29th Floor - M-529.00: Change Areas, Before and After

Snowflake Fitout - 7 Times Square, Floors 29-31 | COP-SF-05 Bulletin 3 Revision

29-1 North supply main - reroute through existing beam cuts \$15,075

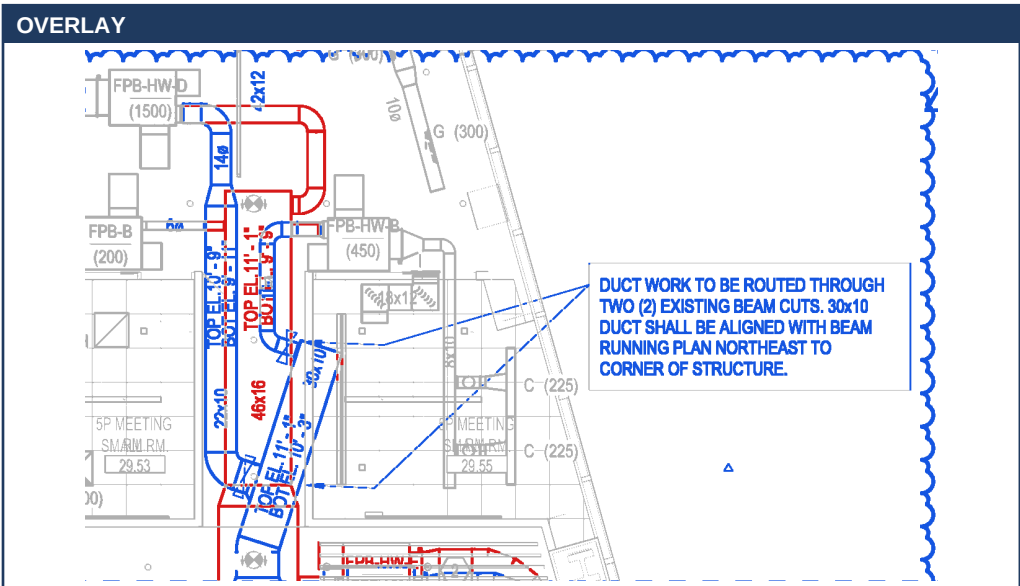
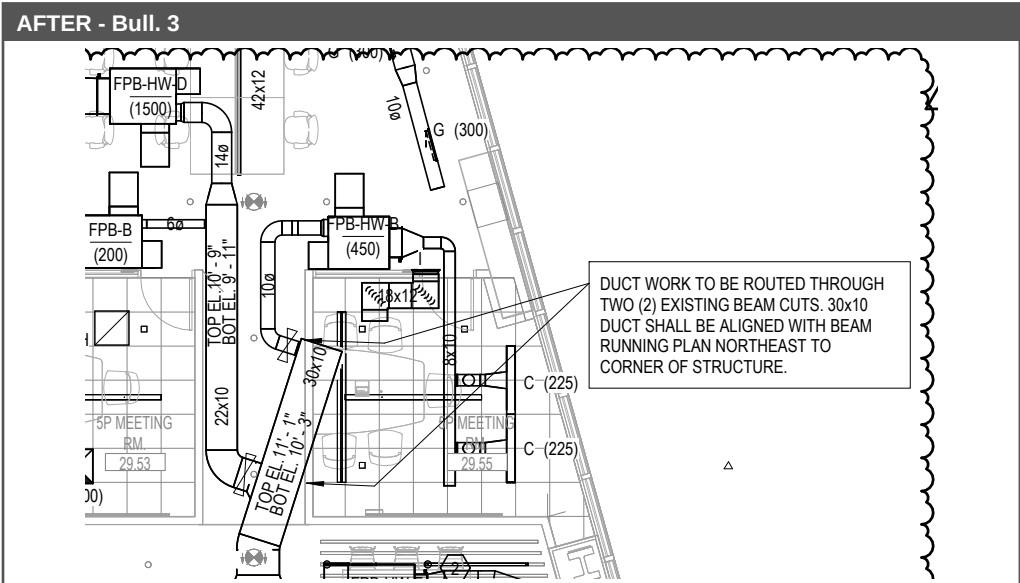
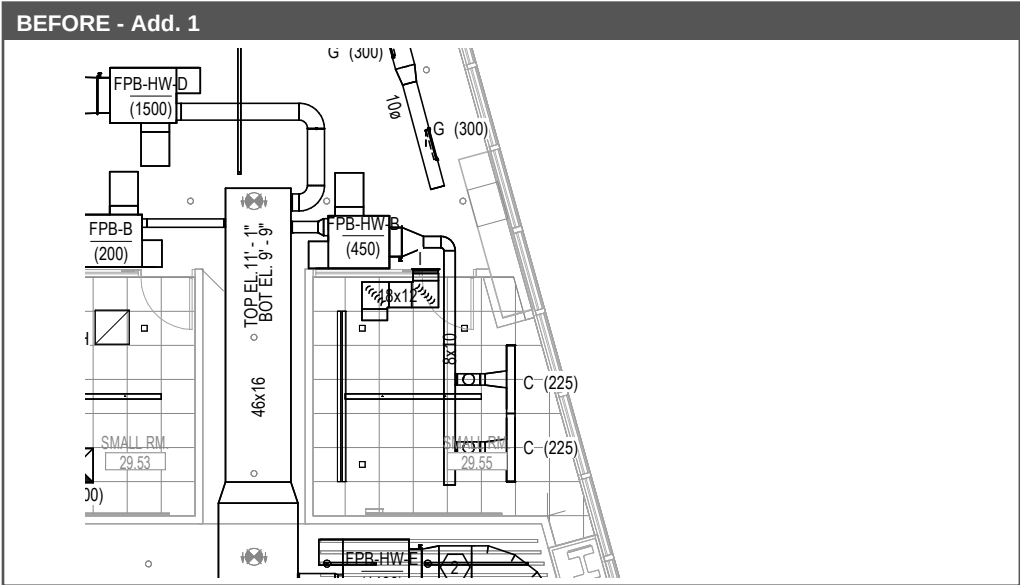
Area	Scope of work	Disconnect / removal	Material	Install labor	Total
29-1	North supply main - reroute through existing beam cuts Before: 46x16 supply main (approx. 20 LF, bottom el. 9'-9") with branch connections to FPB-HW-D (1500), FPB-HW-B (450) and FPB-B (200). After: Main rerouted as 22x10 and 30x10 through (2) existing beam cuts, 30x10 aligned with the beam running plan northeast. New 14ø branch to FPB-HW-D, 10ø to FPB-HW-B and 6ø to FPB-B. Work: Disconnect and remove installed 46x16 section and branch connections. Fabricate and install 22x10 / 30x10 duct and round branches with insulation, reconnect terminal units.	12 MH \$1,500	\$6,075	60 MH \$7,500	\$15,075
29-2	Supply main resized 56x16 to 42x12 Before: 56x16 supply main, approx. 44 LF, top el. 11'-1" / bottom el. 9'-9", Break Rm 29.57 to P.E. After: Main resized to 42x12 on the same route, top el. 11'-1" / bottom el. 10'-1". Work: Disconnect and remove installed 56x16 main. Fabricate and install 42x12 main with insulation, reconnect branch takeoffs (FPB-HW-E, FPB-B (260)).	7 MH \$875	\$3,900	50 MH \$6,250	\$11,025

29-3 FPB-HW-E (1400) relocation and discharge reroute \$2,500

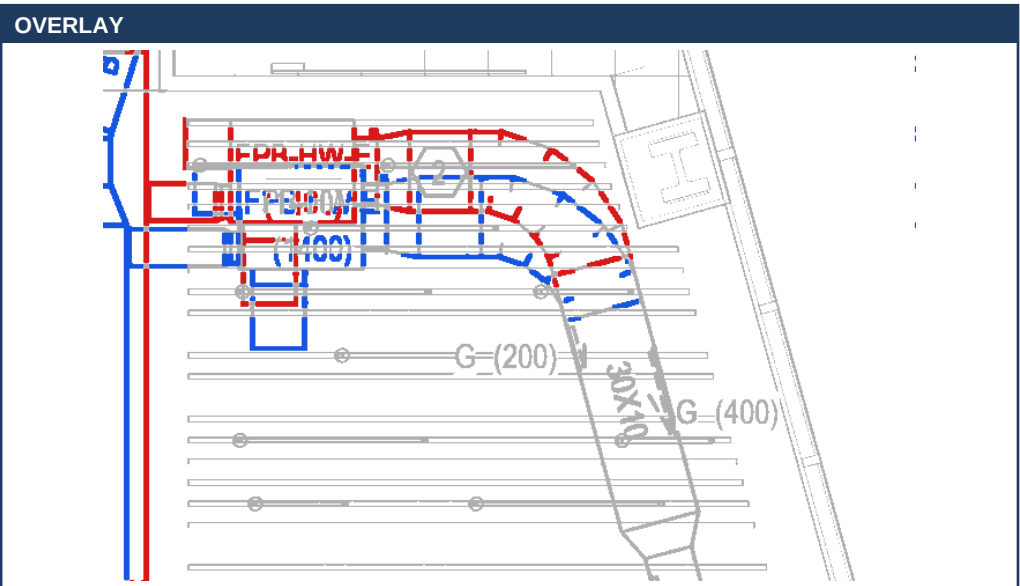
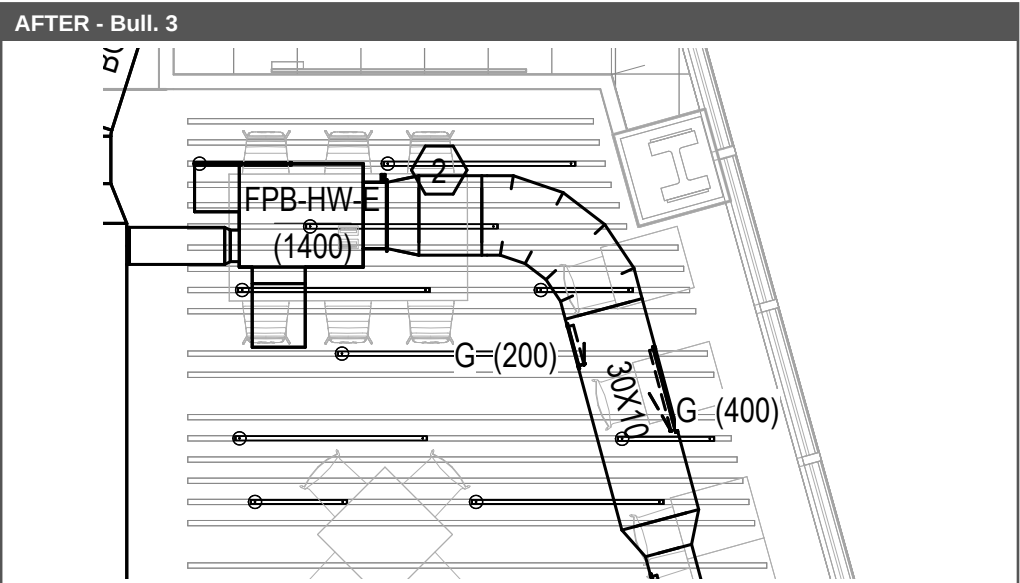
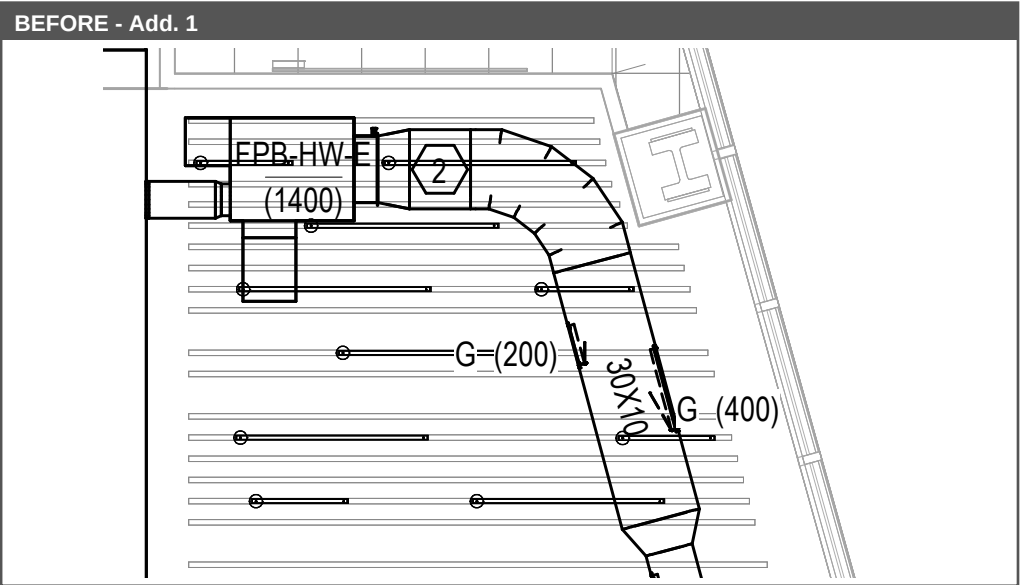
29-3	FPB-HW-E (1400) relocation and discharge reroute Before: FPB-HW-E (1400) with inlet and 30x10 discharge to the G(400) / G(200) linear diffusers along the northeast wall. After: FPB-HW-E relocated; inlet connection and 30x10 discharge elbow rerouted. Work: Disconnect inlet and discharge, relocate and rehang FPB-HW-E, fabricate and install new inlet and 30x10 discharge fittings, reconnect.	2 MH \$250	\$750	12 MH \$1,500	\$2,500
	Shop drawings for revised design				\$1,000
	29th floor total (21 MH disconnect, 122 MH install)	\$2,625	\$10,725	\$15,250	\$29,600

30-1 IT Build Rm 30.23 / F&B Storage 30.14 / west dining \$6,700

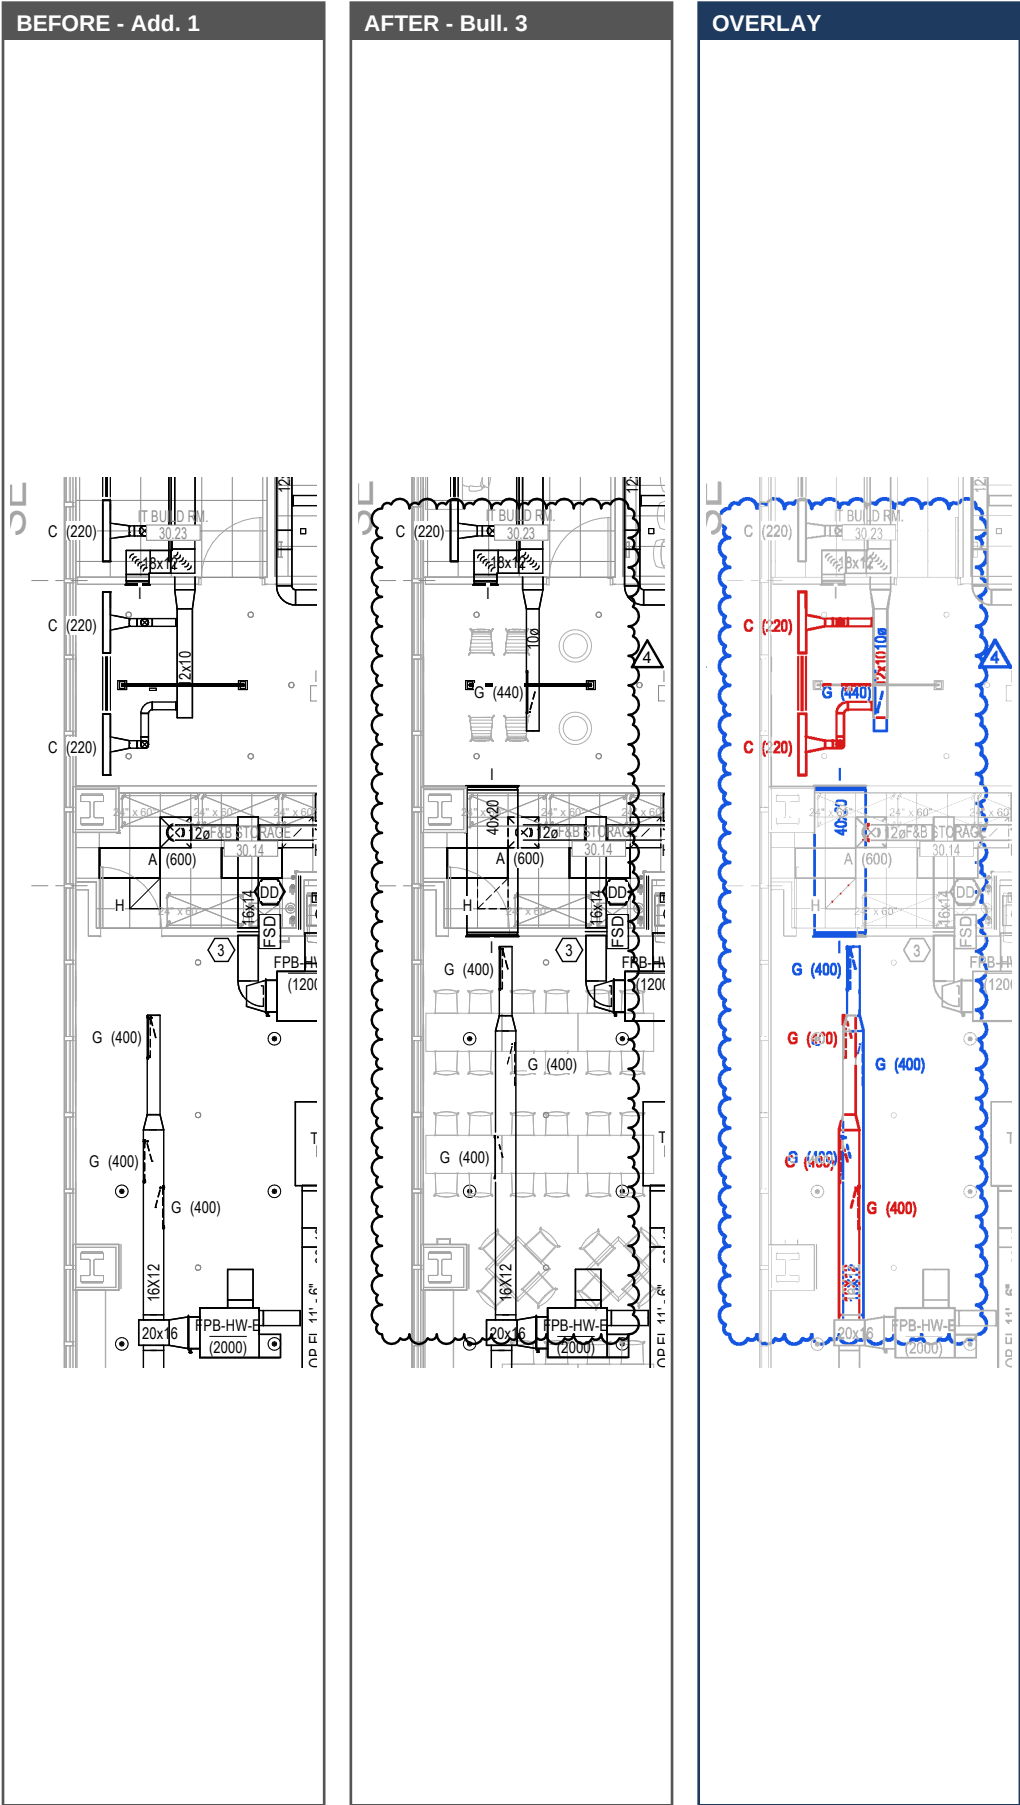
Area	Scope of work	Disconnect / removal	Material	Install labor	Total
30-1	IT Build Rm 30.23 / F&B Storage 30.14 / west dining Before: 12x10 branch with (2) C(220) ceiling diffusers; G(400) linear diffuser run on 16x12 branch. After: 12x10 branch and (2) C(220) deleted, replaced with 10ø branch to (1) new G(440) linear diffuser. New 40x20 transfer duct at F&B Storage 30.14. G(400) linear diffusers relocated along the 16x12 branch. Work: Disconnect and remove 12x10 branch and (2) C(220). Install 10ø branch, 40x20 transfer duct, rework 16x12 branch. F&I G(440) linear diffuser with plenum, relocate G(400) diffusers.	6 MH \$750	\$2,200	30 MH \$3,750	\$6,700
30-2	Lounge 30.02 - new transfer ducts Before: No transfer ducts at Lounge 30.02 walls. After: (2) new 48x24 transfer ducts. Work: Fabricate and install (2) 48x24 lined transfer ducts.	-	\$2,150	26 MH \$3,250	\$5,400
30-3	Meeting Rms 30.04 / 30.05, Storage 30.09, Vestibule 30.07 Before: FPB-HW-B (300) with supply connections; 44x20 transfer duct; (2) 12x12 grilles; 12ø branch to FPB-HW-D (1200). After: 44x20 transfer duct relocated; (2) 12x12 grilles relocated to 5P / 7P Meeting; 12ø branch rerouted. Work: Disconnect and remove affected duct, fittings and grilles. Install 44x20 transfer duct and 12ø branch at new locations.	16 MH \$2,000	-	24 MH \$3,000	\$5,000

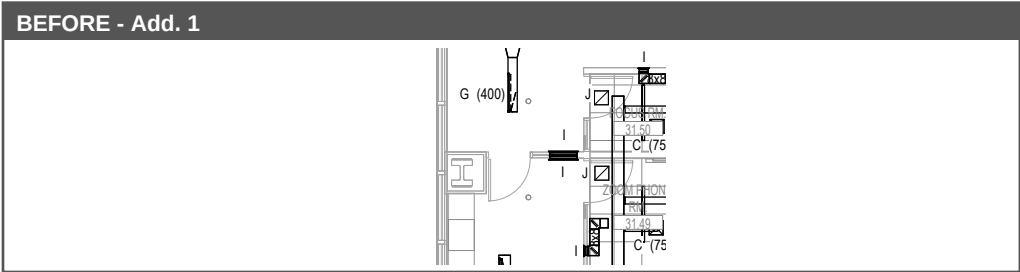
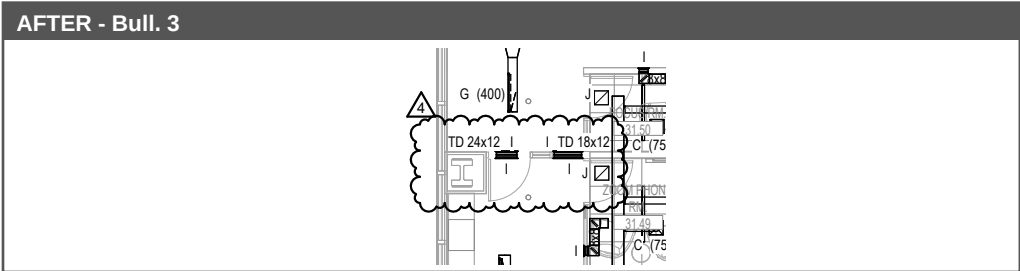
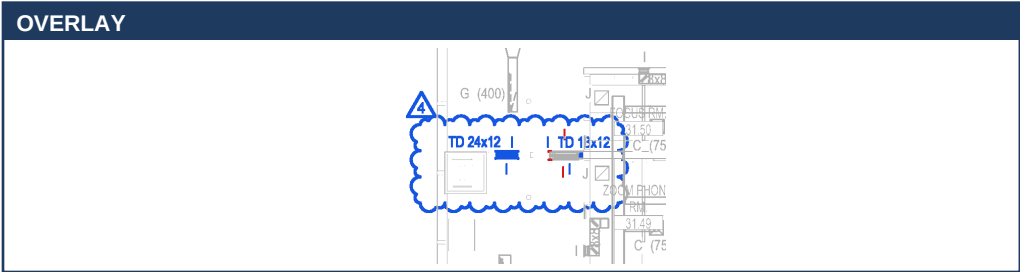
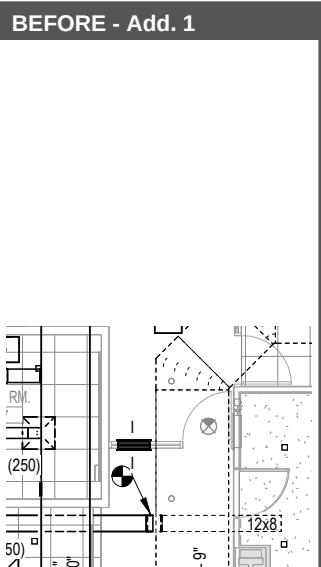
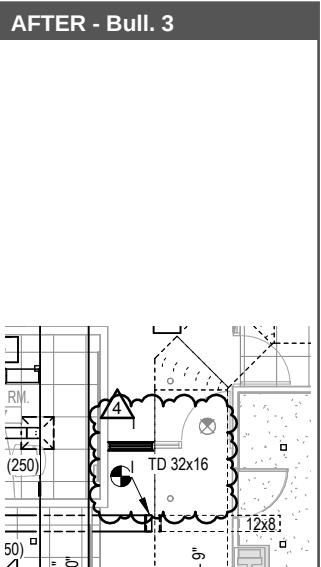
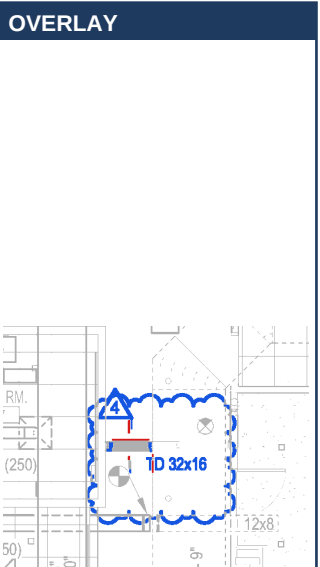
31-1 Zoom rooms, northwest - transfer ducts \$1,205	31-2 Transfer duct TD 32x16, north \$1,050			31-3 Storage 31.02 - new transfer ducts \$4,200
BEFORE - Add. 1  AFTER - Bull. 3  OVERLAY 	BEFORE - Add. 1  AFTER - Bull. 3  OVERLAY 			BEFORE - Add. 1  AFTER - Bull. 3  OVERLAY 
31-4 Coffee Bar 31.12 - transfer ducts and main fitting \$5,450	31-5 Transfer duct TD 32x16, southwest \$3,150			31-6 Storage 31.15 / Room 31.16, southeast \$3,025
BEFORE - Add. 1  AFTER - Bull. 3  OVERLAY 	BEFORE - Add. 1  AFTER - Bull. 3  OVERLAY 			BEFORE - Add. 1  AFTER - Bull. 3  OVERLAY

Area	Scope of work	Disconnect / removal	Material	Install labor	Total
31-1	Zoom rooms, northwest - transfer ducts Before: (1) transfer duct (not sized on Addendum 1). After: TD 24x12 and new TD 18x12. Work: Remove existing transfer duct; fabricate and install TD 24x12 and TD 18x12.	1 MH \$125	\$330	6 MH \$750	\$1,205
31-2	Transfer duct TD 32x16, north Before: Transfer duct as installed per Addendum 1 (not sized on Addendum 1). After: Transfer duct revised to TD 32x16. Work: Remove installed transfer duct; fabricate and install TD 32x16.	1 MH \$125	\$300	5 MH \$625	\$1,050
31-3	Storage 31.02 - new transfer ducts Before: No transfer ducts; volume damper at FPB-HW-B (500) branch. After: (2) new 44x22 transfer ducts. Work: Fabricate and install (2) 44x22 lined transfer ducts.	-	\$1,700	20 MH \$2,500	\$4,200
31-4	Coffee Bar 31.12 - transfer ducts and main fitting Before: 36x18 main with elbow at Coffee Bar 31.12; no transfer ducts. After: (2) new TD 28x16; 36x18 main elbow reconfigured. Work: Disconnect and remove 36x18 elbow; fabricate and install new fitting and (2) TD 28x16.	6 MH \$750	\$1,700	24 MH \$3,000	\$5,450

31-5	Transfer duct TD 32x16, southwest Before: Transfer duct and duct elbow as installed per Addendum 1, next to the 12x8 branch. After: Transfer duct revised to TD 32x16; elbow deleted. Work: Remove installed transfer duct and elbow; fabricate and install TD 32x16.	4 MH \$500	\$650	16 MH \$2,000	\$3,150
31-6	Storage 31.15 / Room 31.16, southeast Before: 12x12 and 18x12 grilles at previous locations; no transfer duct at Storage 31.15. After: New TD 48x24; 12x12 and 18x12 grilles relocated. Work: Remove grilles and their duct connections; fabricate and install TD 48x24, relocate 12x12 and 18x12 grilles with duct connections at new locations.	5 MH \$625	\$900	12 MH \$1,500	\$3,025
	Shop drawings for revised design				\$1,000
	31st floor total (17 MH disconnect, 83 MH install)	\$2,125	\$5,580	\$10,375	\$19,080
